Addendum #1

November 18, 2025

**NC Department of Natural & Cultural Resources
Archives & History / State Library Building – Chiller Replacement
Raleigh, NC
SCO #23-27063-01A
SSME #23023**

1 PARTIAL GROUND FLOOR DEMOLITION PLAN - MECHANICAL
SCALE: 1/4" = 1'-0"

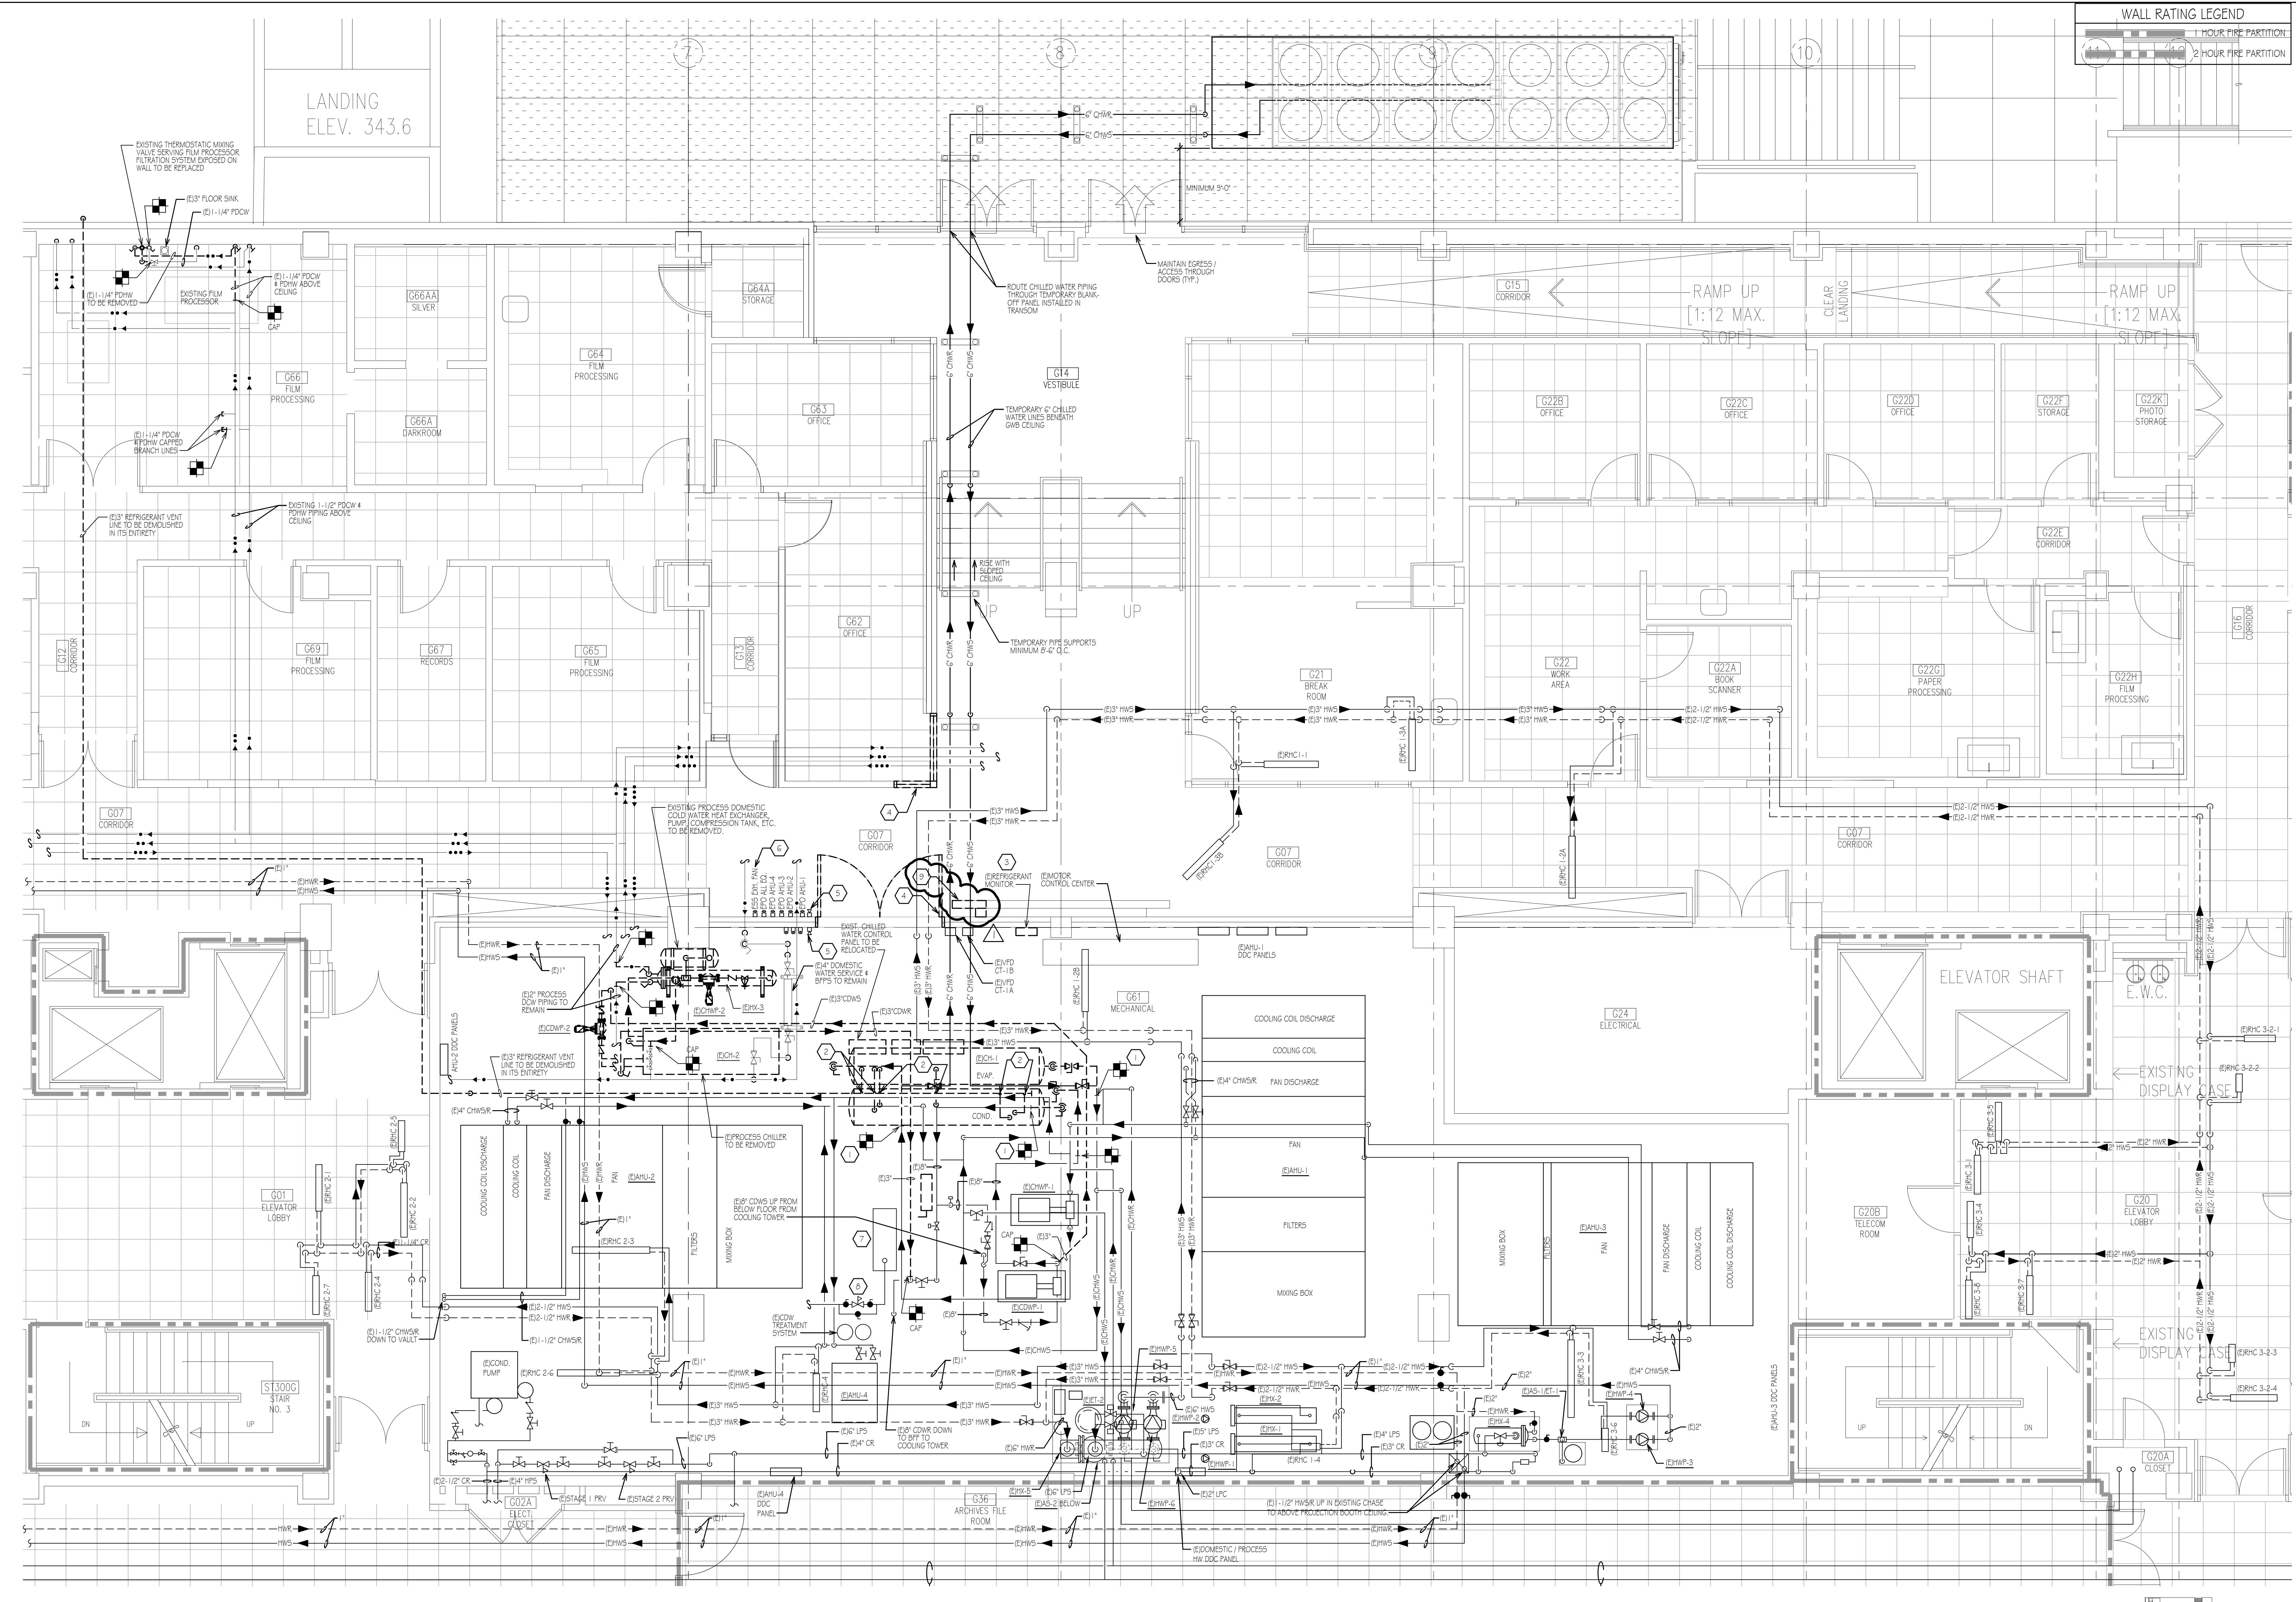
- a. Paragraph 2.2.H.2.: Revise paragraph as follows: “Refrigerant Type: R-513a. Classified as Safety Group A1 according to ASHRAE 34.”
4. **Refer to Construction Documents – Drawings, Sheet M1.1:** Refer to the attached drawing for the following revision:

- a. Keyed Note “9” has been added to read: “Remove section of existing wall feature in Corridor G07 for installation of temporary chilled water piping. Replace removed section of wall feature upon demolition of temporary chilled water piping, matching existing construction and finishes.”

- 7 EXISTING COMPRESSION TANK AT CEILING TO REMAIN.
 - 8 EXISTING MAKE-UP WATER ASSEMBLY TO REMAIN.
 - 9 REMOVE SECTION OF EXISTING WALL FEATURE IN CORRIDOR G07 FOR INSTALLATION OF TEMPORARY CHILLED WATER PIPING. REPLACE REMOVED SECTION OF WALL FEATURE UPON DEMOLITION OF TEMPORARY CHILLED WATER PIPING, MATCHING EXISTING CONSTRUCTION AND FINISHES.
